Access Compliance Report

Public Rights-of-Way

(Curb Ramps)

Intersection ID: 47903	Main Street: SPUR_RANCH_RD	Cross Street: ROUND_ROCK_RD	Location: S
ADA ID: 01274848D58F	Ramp Type: PerpDiag	Initial Pass/Fail: Fail	Overall Compliance: No
Severity Score: 8.75			
Codes/Mitigation Info/Possible Solution		Field Measurements/Component Compliance

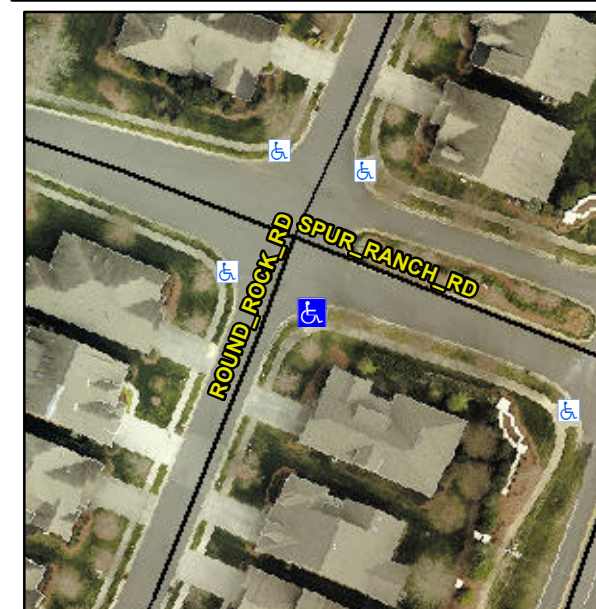
Not Found, R304.5.1

Compliance	Description	Data	Compliance	Description	Data
N/A	Ramp Length (in)	132.0	Yes	Ramp Slope (%)	6.4
No	Ramp Width (in)	46.0	Yes	Ramp XSlope (%)	1.5
N/A	Flare Type LT	N/A	N/A	Flare Type RT	N/A
N/A	Flare Slope LT (%)	N/A	N/A	Flare Slope RT (%)	N/A
N/A	Flare Traversable LT?	N/A	N/A	Flare Traversable RT?	N/A
N/A	Landing Length (in)	N/A	N/A	DWS Provided?	N/A
N/A	Landing Width (in)	N/A	N/A	DWS Contrast?	N/A
N/A	Landing Slope (%)	N/A	N/A	DWS Length (in)	N/A
N/A	Landing X Slope (%)	N/A	N/A	DWS Full Width?	N/A
N/A	Landing Curb? (Y/N)	N/A	N/A	DWS Offset (in)	N/A
N/A	Shared Landing?	N/A			
N/A	Gutter Ponding?	N/A	N/A	Gutter Slope (%)	N/A
N/A	Gutter Lip Ht (in)	N/A	N/A	Gutter X Slope (%)	N/A
N/A	Painted X Walk1?	No	N/A	Painted X Walk2?	No
	X Walk 1 Direction	To NE		X Walk 2 Direction	To NW
N/A	X Walk 1 Width (in)	N/A	N/A	X Walk 2 Width (in)	N/A
	X Walk 1 Slope (%)	0.2		X Walk 2 Slope (%)	2.6
	X Walk 1 X Slope (%)	2.2		X Walk 2 X Slope (%)	1.6

Remove & Replace Curb Ramp With Two New Directional Ramps or Equivalent.
